WEST MARGINAL FLOAT REPLACEMENT SELDOVIA, ALASKA

THE FOLLOWING PLAN SET CONTAINS ANNOTATIONS DOCUMENTING CHANGES TO THE PROJECT REPORTED TO HAVE BEEN MADE DURING CONSTRUCTION. THESE MARKUPS ARE BASED REDLINES AND RECORDS PROVIDED BY HARRIS SAND & GRAVEL. ANNOTATIONS PREPARED BY MOFFATT & NICHOL ARE FOR INFORMATION PURPOSES ONLY.

BID SET, 14 FEB 2014
AKV292
P2 NO. 326049

SELDOVIA, ALASKA
WEST MARGINAL FLOAT REPLACEMENT
STRUCTURAL
LARGE-SCALE VIEWS
MODULES M-2 THRU M-8 & M-11 THRU M-15

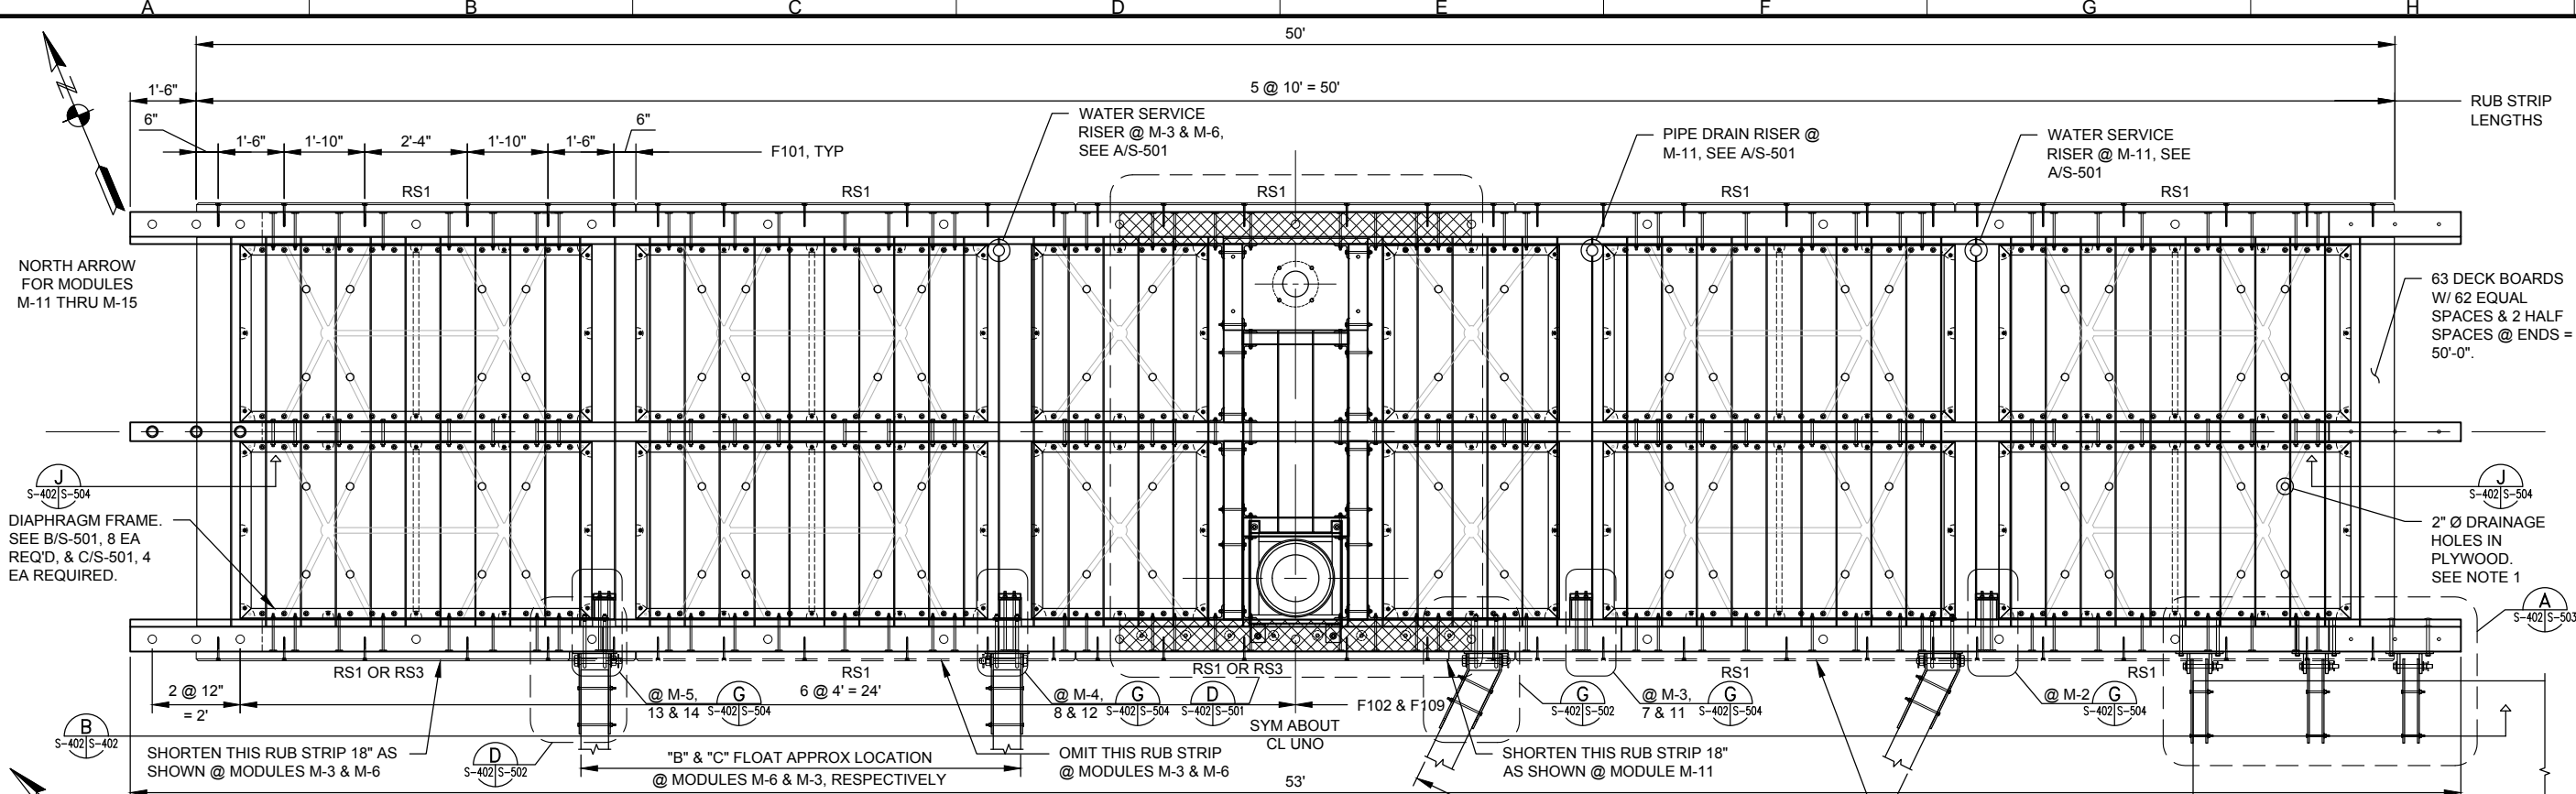
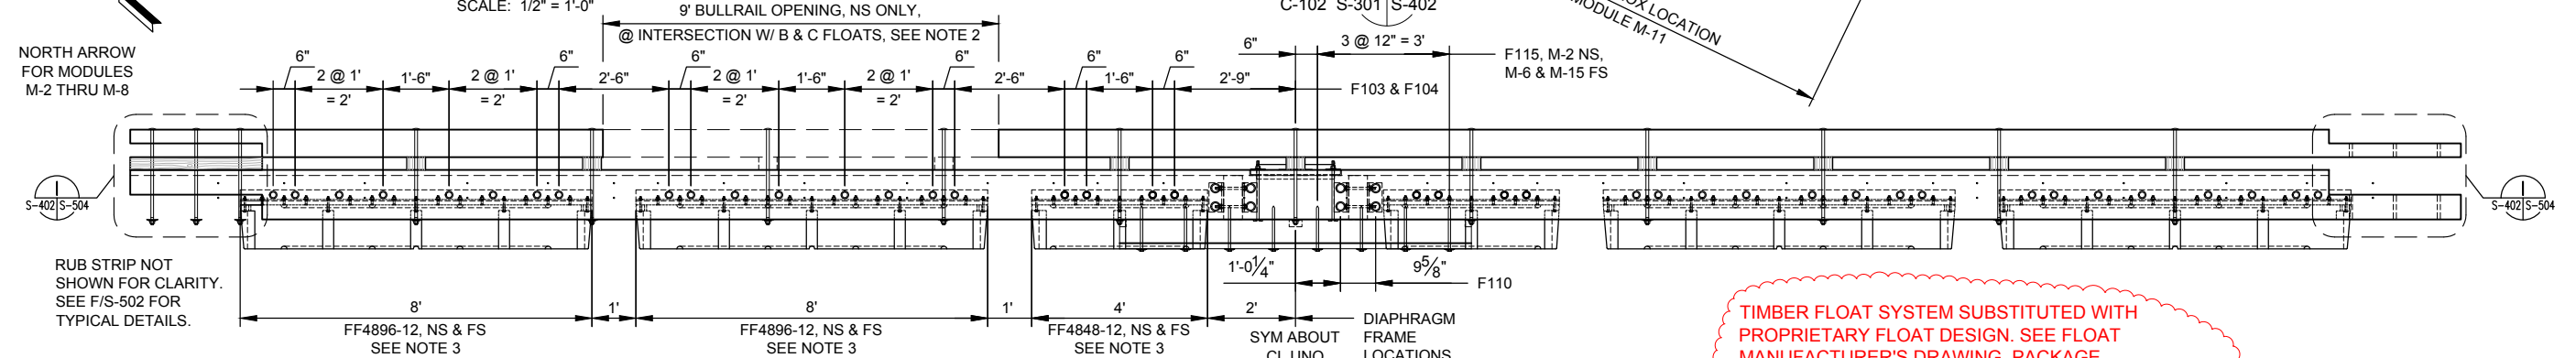
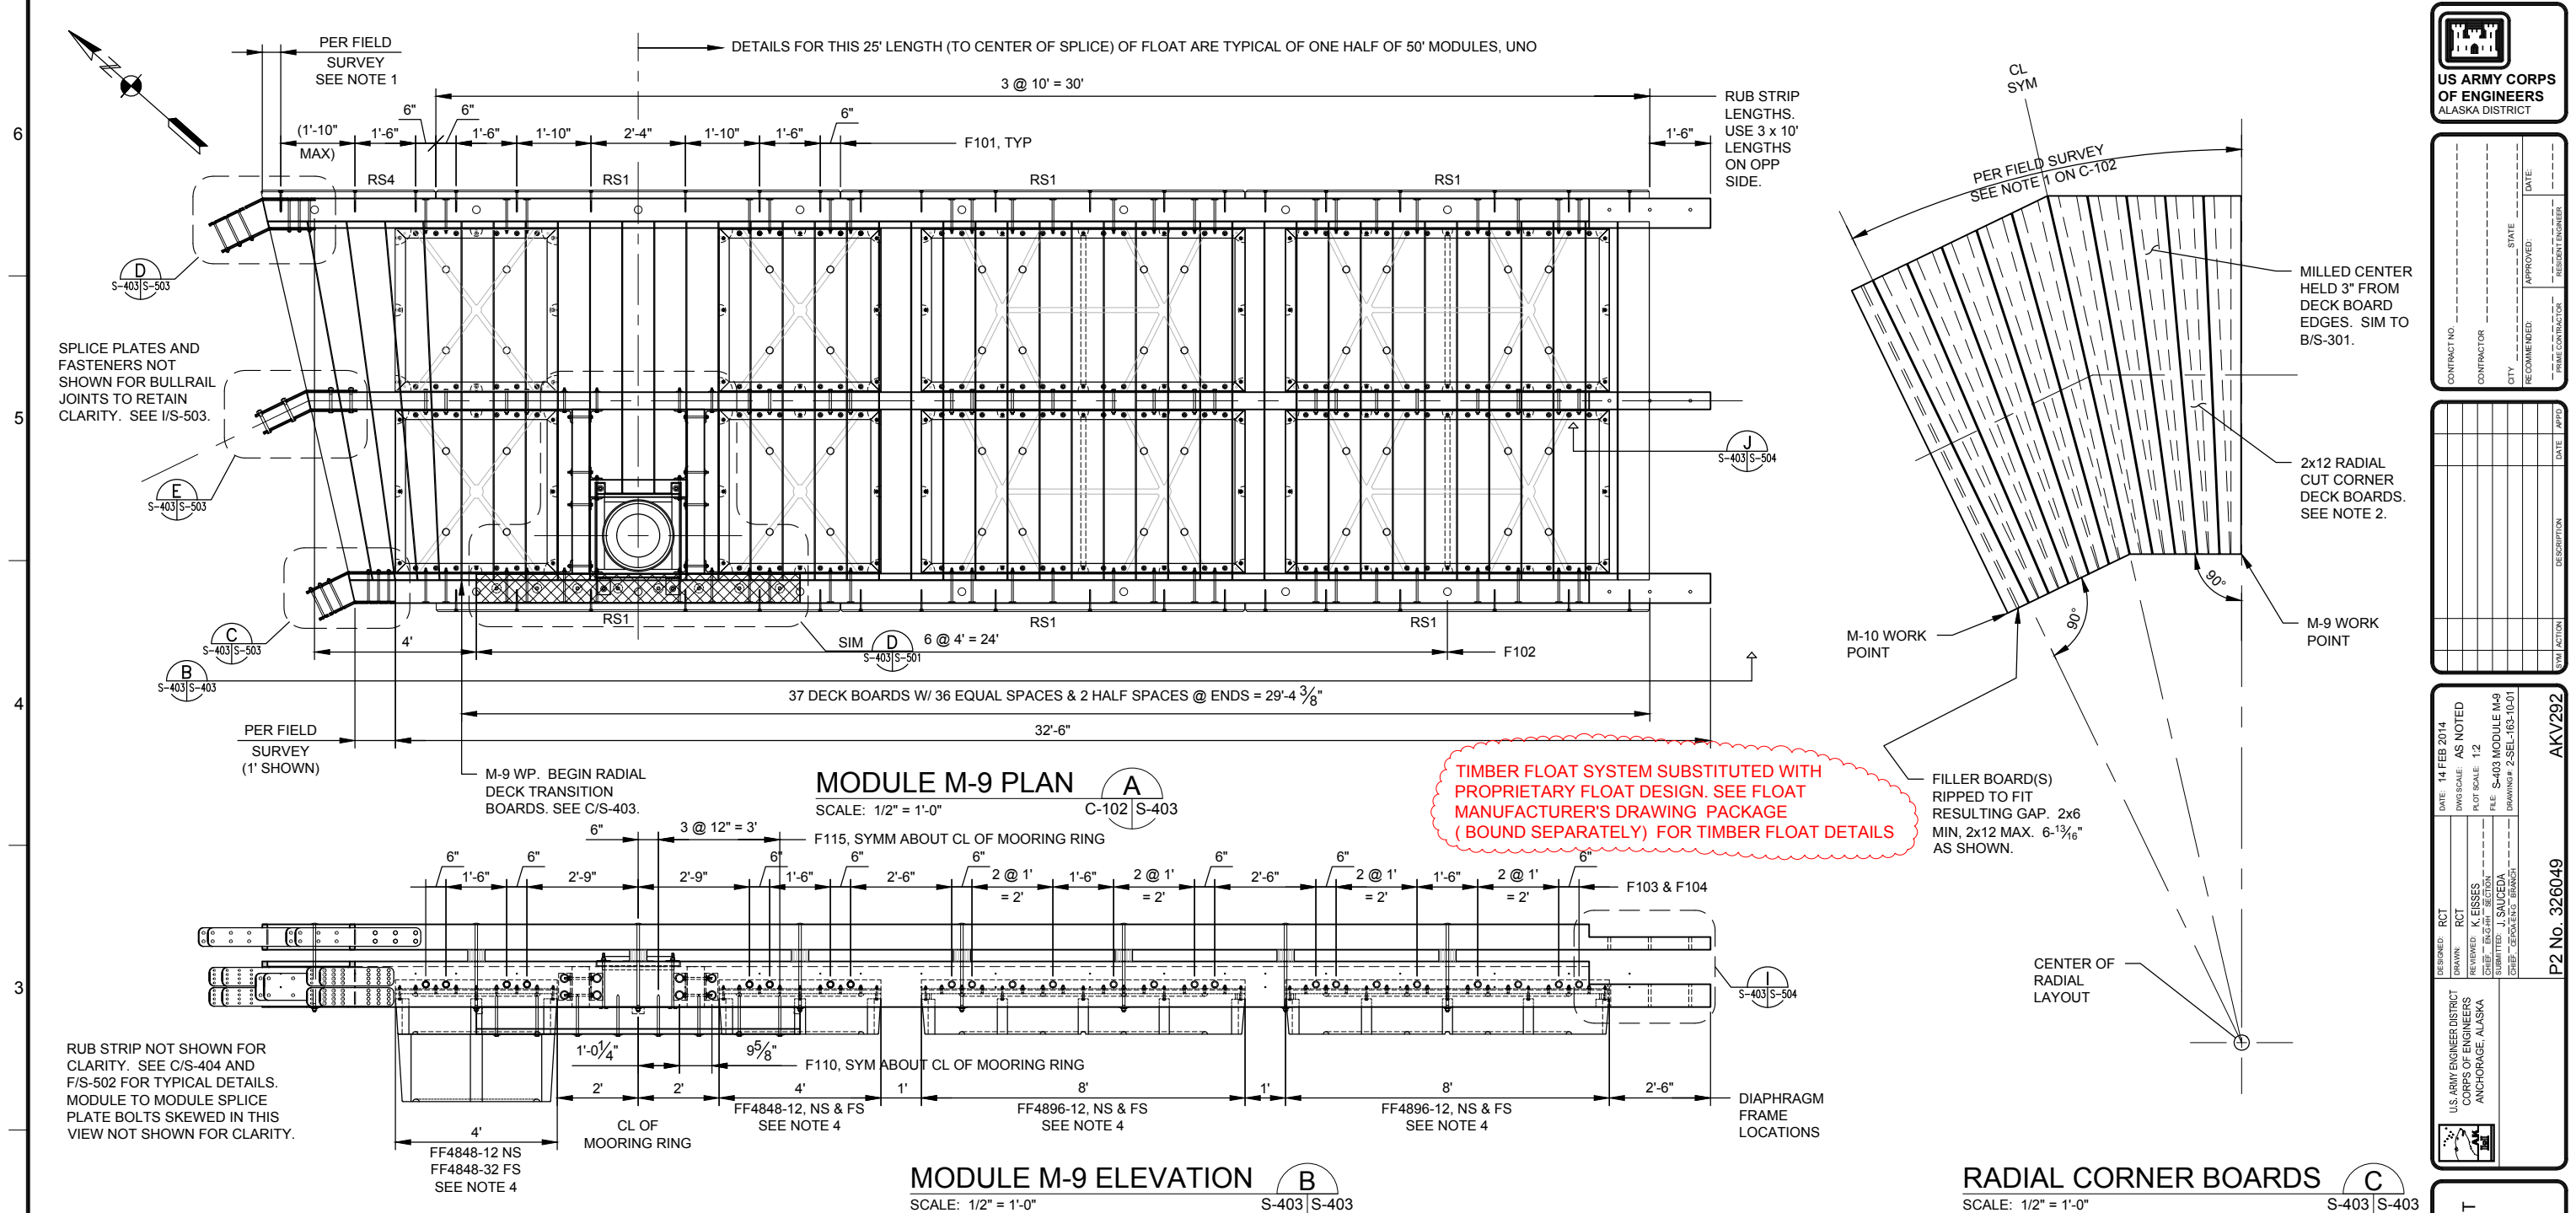
TIMBER FLOAT SYSTEM SUBSTITUTED WITH PROPRIETARY FLOAT DESIGN. SEE FLOAT MANUFACTURER'S DRAWING PACKAGE (BOUND SEPARATELY) FOR TIMBER FLOAT DETAILS

SELDOVIA, ALASKA	
WEST MARGINAL FLOAT REPLACEMENT	
MECHANICAL	
PLANS	
SITE PLAN AND RISER PLANS

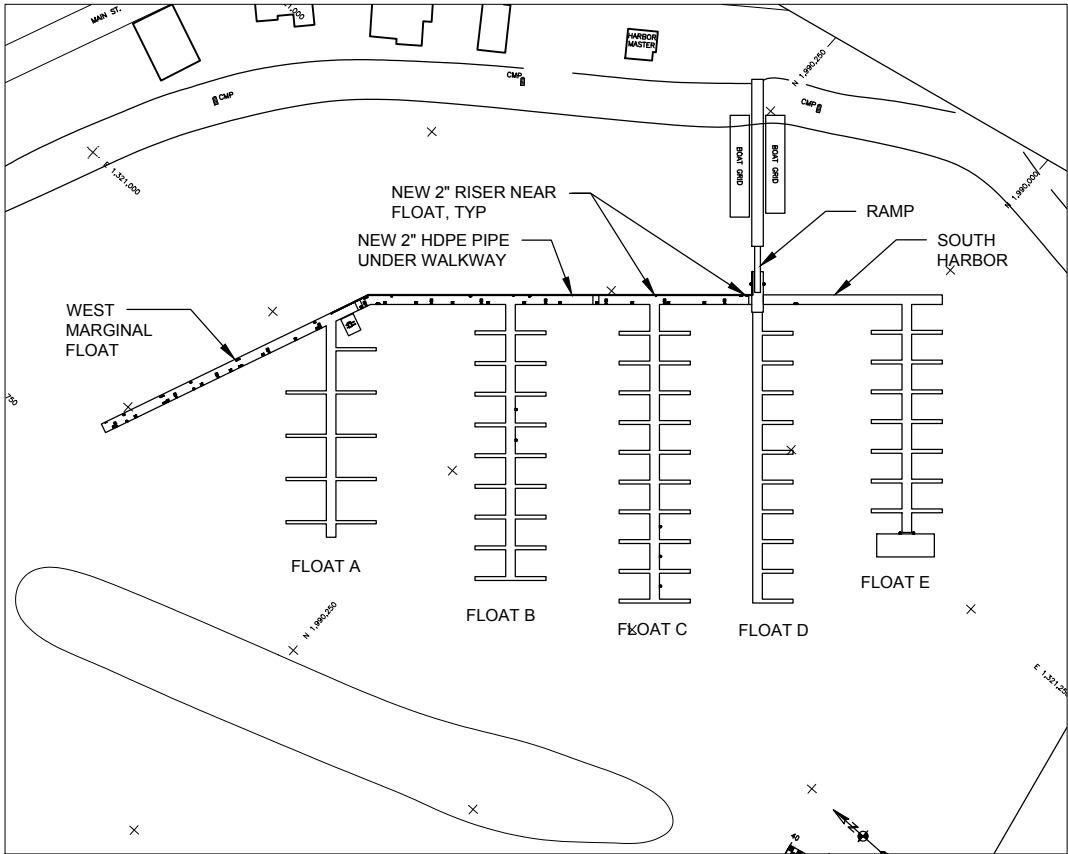
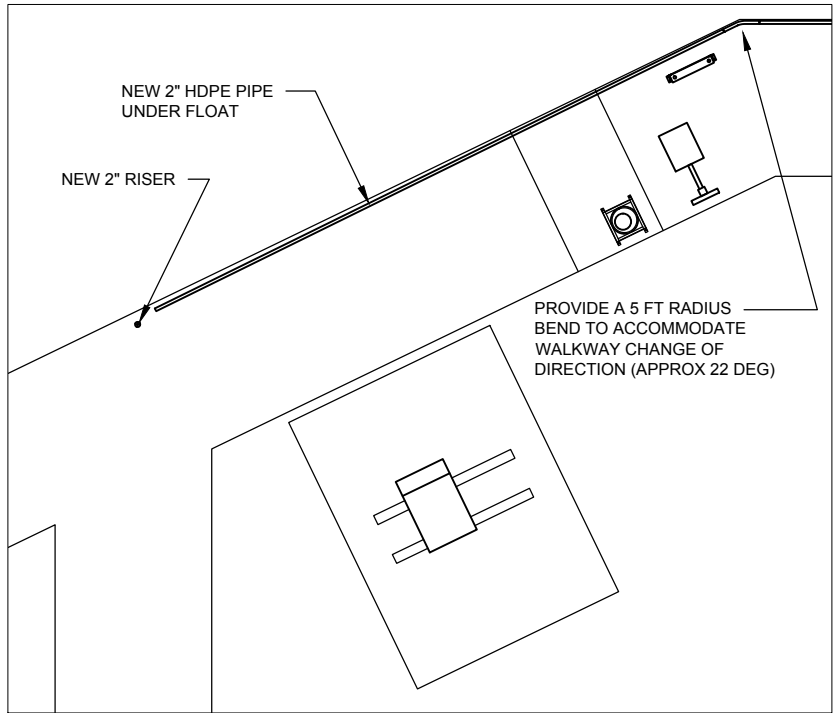
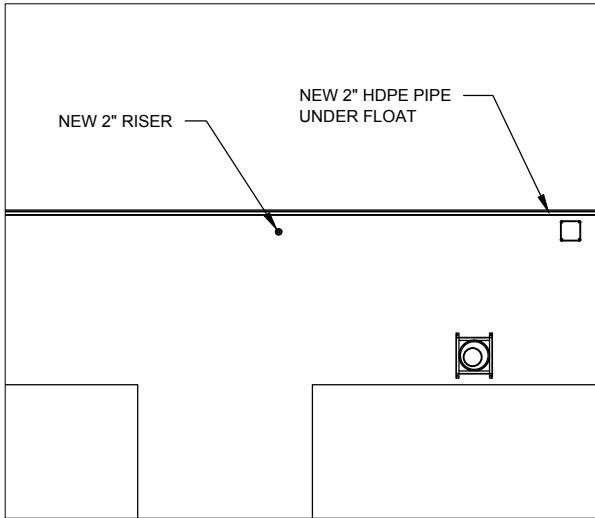
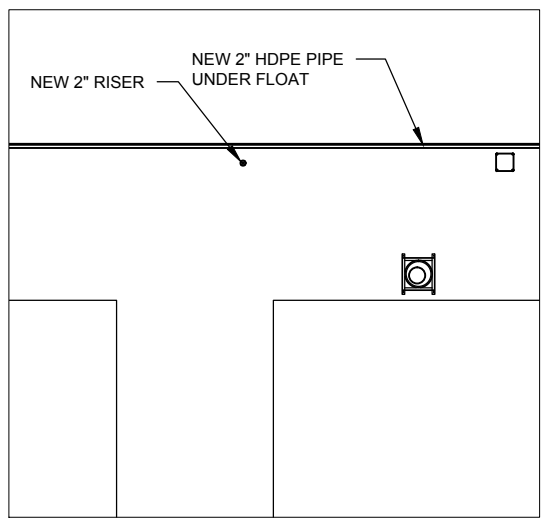
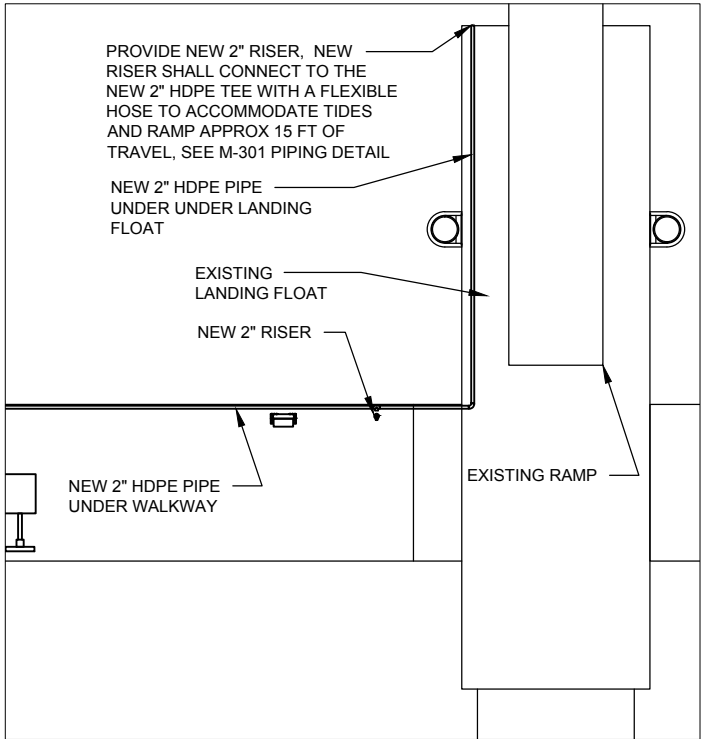
PLUMBING MATERIALS DELIVERED TO CITY OF SELDOVIA BUT WERE NOT INSTALLED AS A PART OF THIS PROJECT.
